Penske (DPR) Feedback Response – Bolt at the upper steering shaft where it meets the column

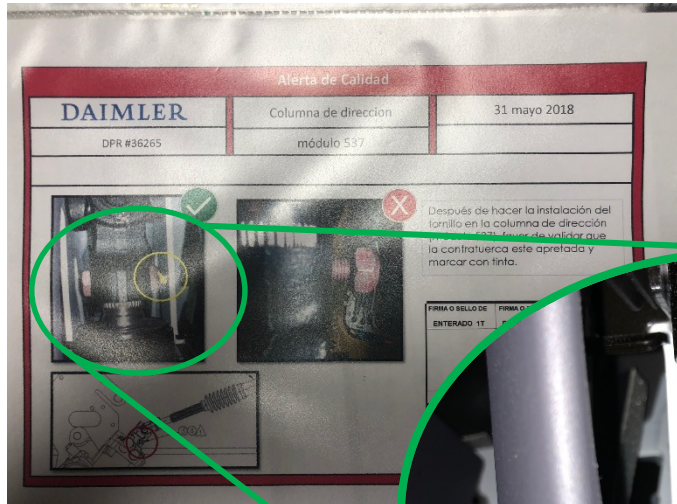
Problem Description: <ul style="list-style-type: none">Loose pinch bolts in steering column		First Reported Date:	May, 11 th , 2018
		Customer:	Penske
Possible Causes: <ul style="list-style-type: none">The documented procedure was not followed.Tool in the process with torque out of specification		Claim Rate:	0.1667
		<div><p>Quality Alert</p><p>DAIMLER</p><p>Alerta de Calidad</p><p>Columna de dirección</p><p>31 mayo 2018</p><p>DPR #36265</p><p>módulo 537</p><p>Después de hacer la instalación del tornillo en la columna de dirección, se debe verificar que la contratuera este apretada y marcar con tinta.</p><p>FIRMA O SELLO DE ENTREGADO IT</p></div> <div><p>Quality Alert</p></div>	
Containment Actions: <ul style="list-style-type: none">Quality alert issued in the stationAdd point to inspection checklist on quality gate and put a green markCampaign in offline (30 trucks)			
Root Cause Identified:	Yes

Corrective Actions: <ul style="list-style-type: none">Standard Work Instruction and Job Element Sheet is being updated to improve installation method.A new tool (DC Tool) is in process to be implemented (June 30th)			
Confirmation Date:	May 30 th , 2018
